RECEIVE AND FILE COMMUNICATION FROM THE PLAN AND ZONING COMMISSION REGARDING VACATION OF AN IRREGULAR SEGMENT OF INGERSOLL AVENUE RIGHT-OF-WAY LYING SOUTH OF THE TRAVELLED PORTION OF THE STREET BETWEEN 16TH AND 17TH STREET

Hubbell Realty Company, Ingersoll Avenue Right-of-Way between 16th & 17th Streets 11-2013-1.18

Communication from the City Plan and Zoning Commission advising that at their meeting held December 5, 2013, the following action was taken regarding a request from Hubbell Realty Company (purchaser) represented by Steve Niebuhr (officer) for review and approval of a Site Plan "Artisan Row" under design guidelines for multiple-family dwellings on property located at 1623 Grand Avenue and 525 17th Street to allow development of 27 two-story row dwellings and for vacation of an irregular segment of Ingersoll Avenue right-of-way lying south of the travelled portion of the street between 16th Street and 17th Street, to incorporate within the proposed development site on that block. The subject property is owned by Meredith Corporation.

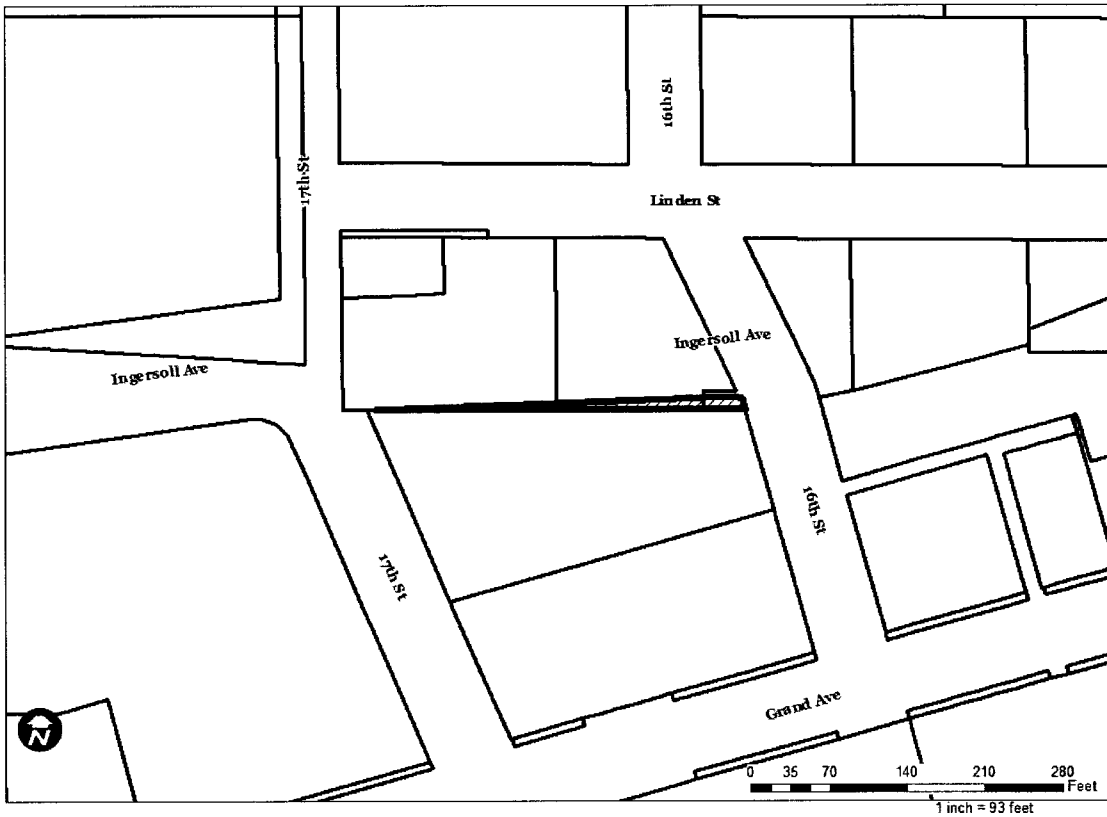
APPROVAL of the vacation of an irregular segment of Ingersoll Avenue right-of-way lying south of the travelled portion of the street between 16th Street and 17th Street, to incorporate within the proposed development site on that block subject to the provision of any necessary easements for existing utilities. (11-2013-1.18)

Item 3) Staff recommends approval subject to the provision of any necessary easements for existing utilities.
